IRON HAMMER AT CENTRETECH - SITE PLAN AMENDMENT

SITE PLAN AMENDMENT
IRON HAMMER AT CENTRETECH
255 LAREDO STREET
AURORA, CO
JESSE DONOVAN, P.E. 720-504-8629

REVISION NUMBER	REVISION DESCRIPTION	DATE
00		09/21/2023
01	FIRST SUBMITTAL	02/05/2024
	SECOND SUBMITTAL

LANDSCAPE PLAN

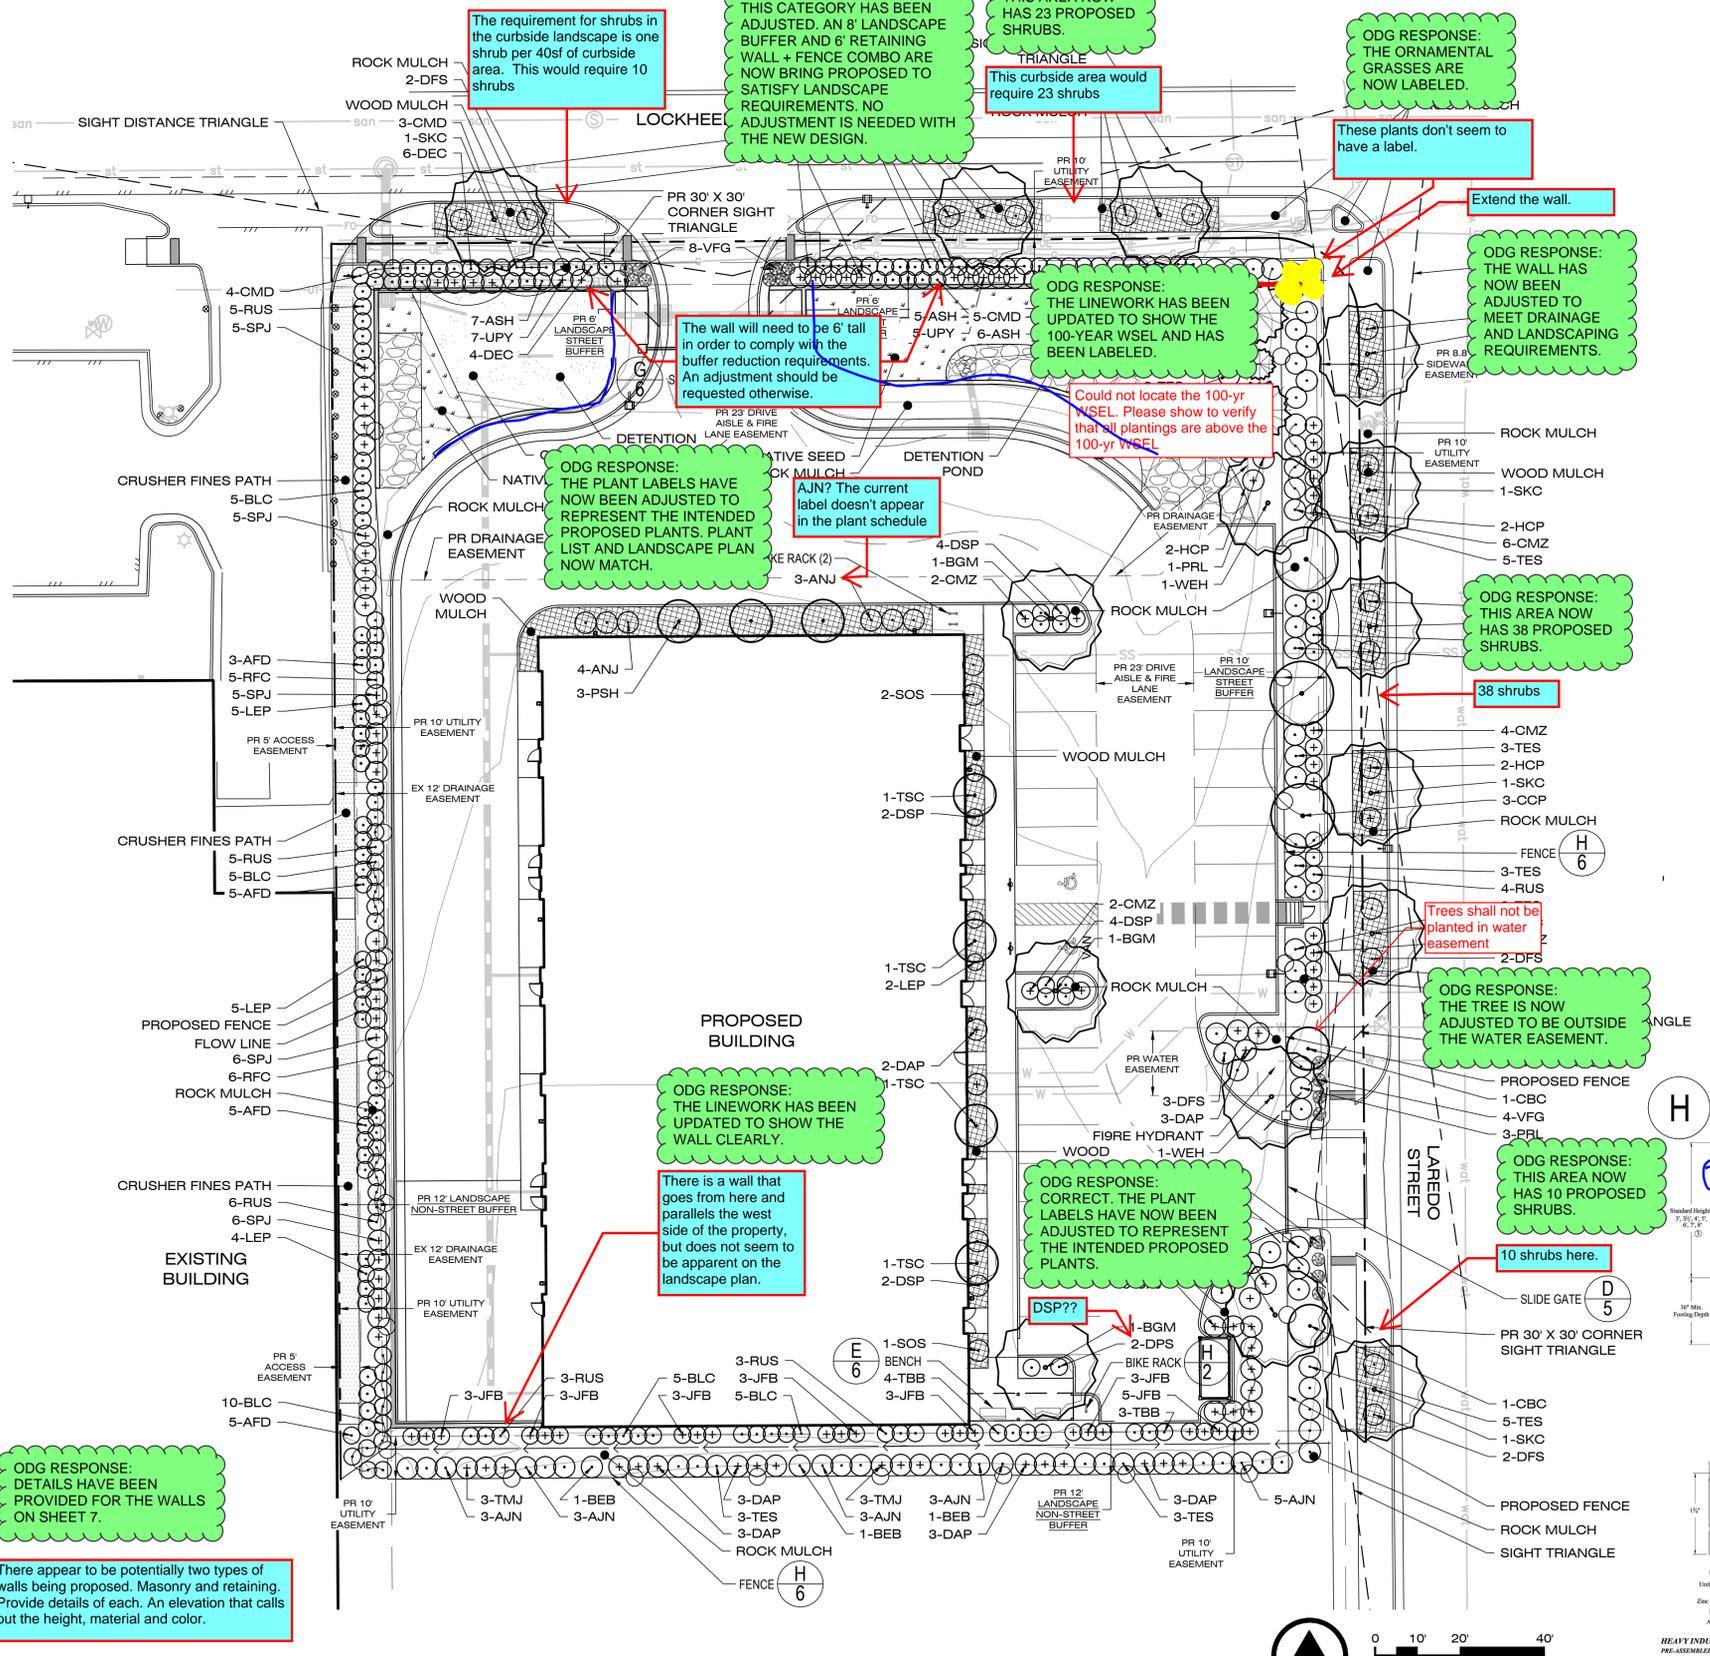
The wall has to be 6' tall in accordance with code and this wall does not appear to be that tall. See additional commentary on the landscape plan.

ODG RESPONSE: THIS CATEGORY HAS BEEN ADJUSTED. AN 8' LANDSCAPE BUFFER AND 6' RETAINING WALL + FENCE COMBO ARE NOW BRING PROPOSED TO SATISFY LANDSCAPE REQUIREMENTS.

ODG RESPONSE: THE LANDSCAPE CHART IS NOW UPDATED; SHRUB CURBSIDE CALCULATIONS ARE NOW BASED OFF OF SF. VS. LF.
